APPLICATION NO.	FILING DATE	FIRST NAMED INVENTOR	ATTORNEY DOCKET NO.	CONFIRMATION NO.
09/677,870	10-03-2000	Woo Hyuk Choi	2658-0240P	6124

Office Action Summary

DETAILED ACTION

FIG. 6

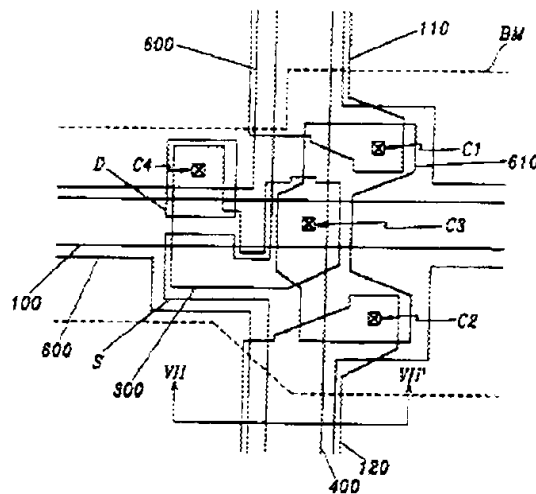
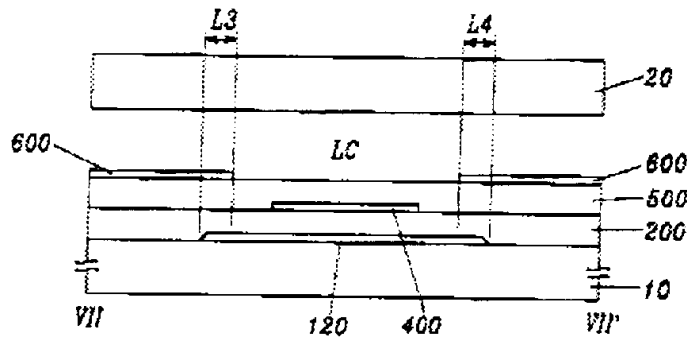
As to claims 1 and 2, Kim discloses in the third embodiment, Figures 6 and 7, (col. 6, line 35 through col. 7, line 5), a thin film transistor substrate in a liquid crystal display provided with a data line, 400, for applying a data signal, a gate line, 100, for applying a gate signal, and a transparent pixel electrode, 600, for driving a liquid crystal cell, said substrate comprising: repair lines, 110 and 120, (Applicant's gate dummy pattern) formed of the same material layer as the gate line (col. 6, lines 38-42 and col. 2, lines 10-17) so as to extended vertically from the gate line, 100, and to overlap the pixel electrode, 600, and data line 400, to compensate for misalignment occurring along the data line.

Kim does not explicitly disclose a display wherein the gate dummy pattern is integrated with the data line.

FIG. 19A

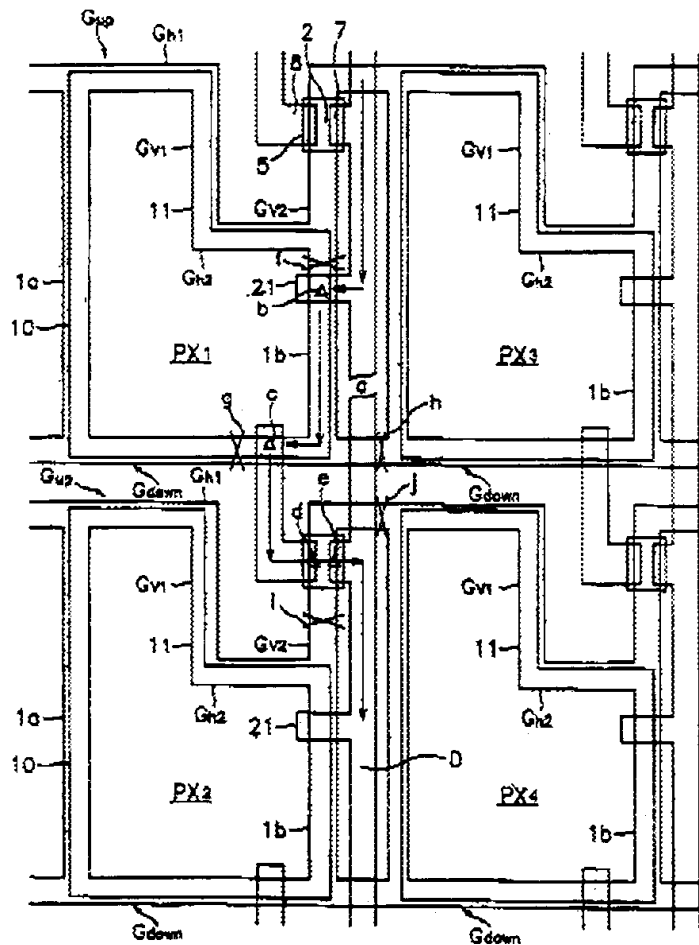
Song teaches the use of a redundant pattern that is integrated with the gate line in Figure 19A (G_{up} and G_{down} or 1a and 1b) as a redundancy electrode for electrically connecting the gate line to the broken data line (col. 17, lines 4-67, especially col. 17, lines 47-54) to effect repairs.

Song is evidence that ordinary workers in the art of liquid crystals would find the reason, suggestion, or motivation to form the gate dummy pattern in such a manner as to serve as a redundancy electrode for electrically connecting the gate line to the broken data line to effect repairs.

FIG. 13

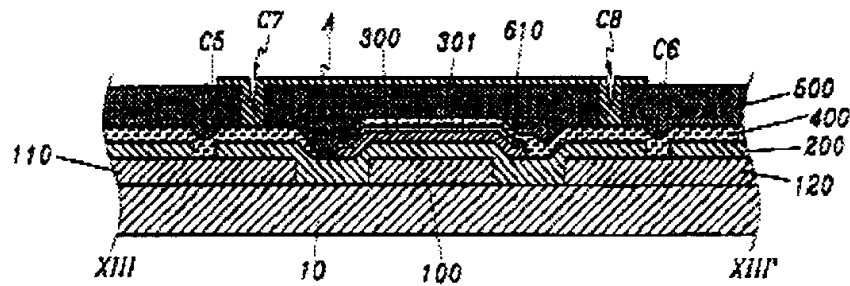
Kim teaches in Figure 13 the use of forming holes and connections to the repair lines, 110 and 120, (Applicant's gate dummy pattern) and to a connecting pattern, 610, to repair a broken data line, 400, (col. 8, lines 1-15).

FIG. 26

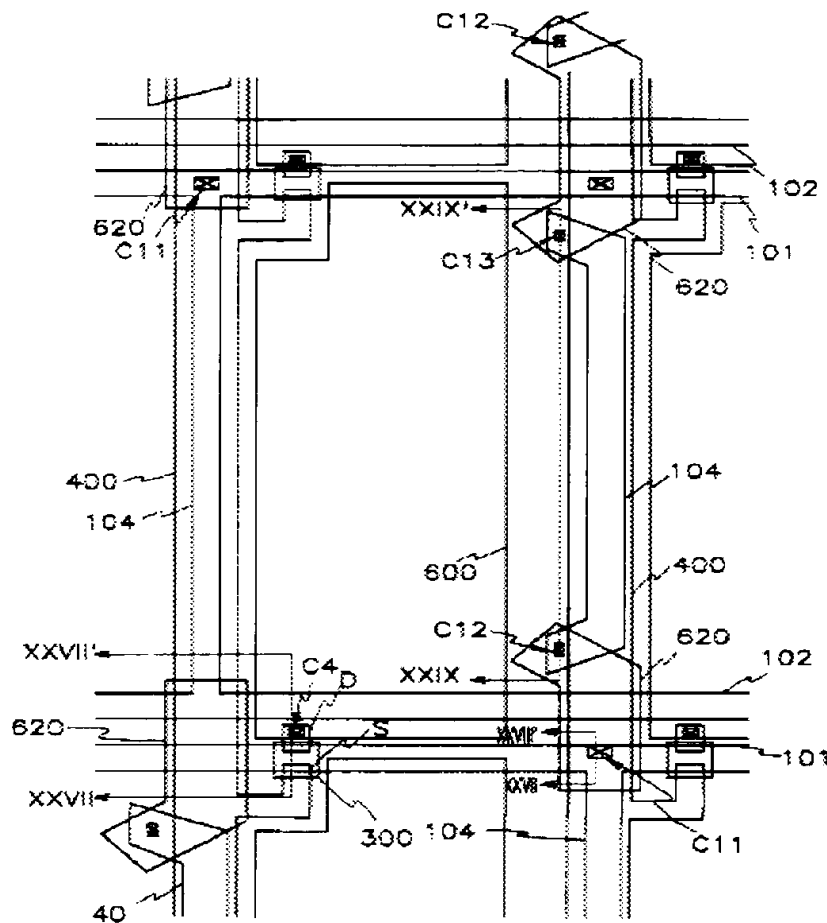
Kim teaches in Figure 26 the use of repair lines, 104, (Applicant's gate dummy pattern used as a redundancy electrode) to connect the gate line to the data line (col. 13, lines 4-17).

Kim is evidence that ordinary workers in the art of liquid crystals would find the reason, suggestion, or motivation to form holes and connect gate dummy patterns to gate lines to repair a broken data line.

FIG. 19A

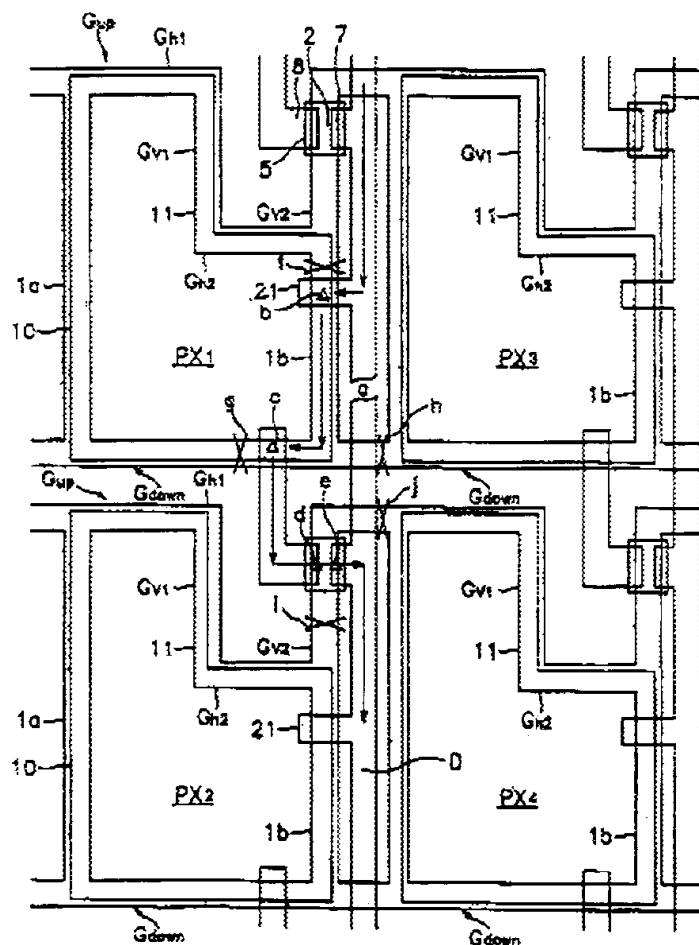
Song teaches the use of a redundant pattern in Figure 19A (G_{up} and G_{down} or 1a and 1b) as a redundancy electrode for electrically connecting the gate line to the broken data line (col. 17, lines 4-67, especially col. 17, lines 47-54) to effect repairs.

Song is evidence that ordinary workers in the art of liquid crystals would find the reason, suggestion, or motivation to form the gate dummy pattern in such a manner as to serve as a redundancy electrode for electrically connecting the gate line to the broken data line to effect repairs.

FIG. 18

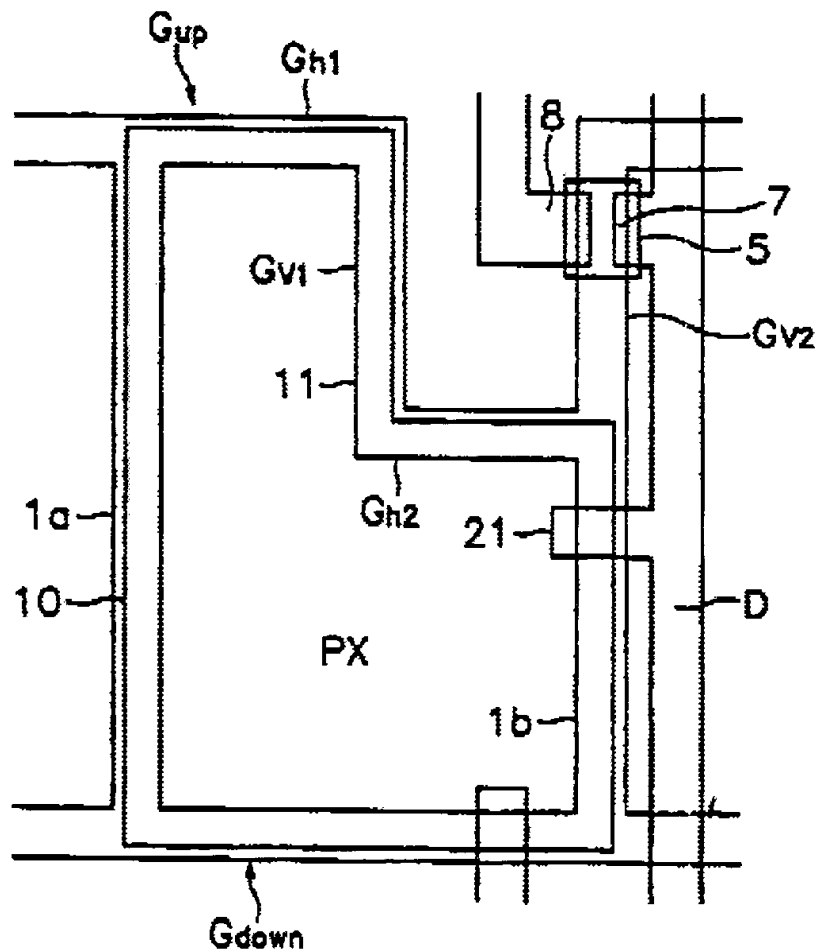
As to claims 6 and 15, Song teaches in Figure 18 a thin film transistor substrate further comprising: a storage capacitor (col. 15, lines 56-64) defined by a horizontal overlapping part, G_{h2} , between the gate line and the pixel electrode, PX. Song also teaches in Figure 18 an analogous overlapping portion, 21, of the data line, D, to permit a repair.

As to claims 7 and 16, Song teaches in Figures 18 and 19A a protrusion, 21, formed in the data line in such a manner to overlap with the intended repair site (Applicant's recess and narrowed portion of the gate dummy patterns), the structure of which would thereby shut off a light leaked between the gate dummy pattern and the gate line (col. 15, lines 42-63). Note that in considering the disclosure of a reference, it
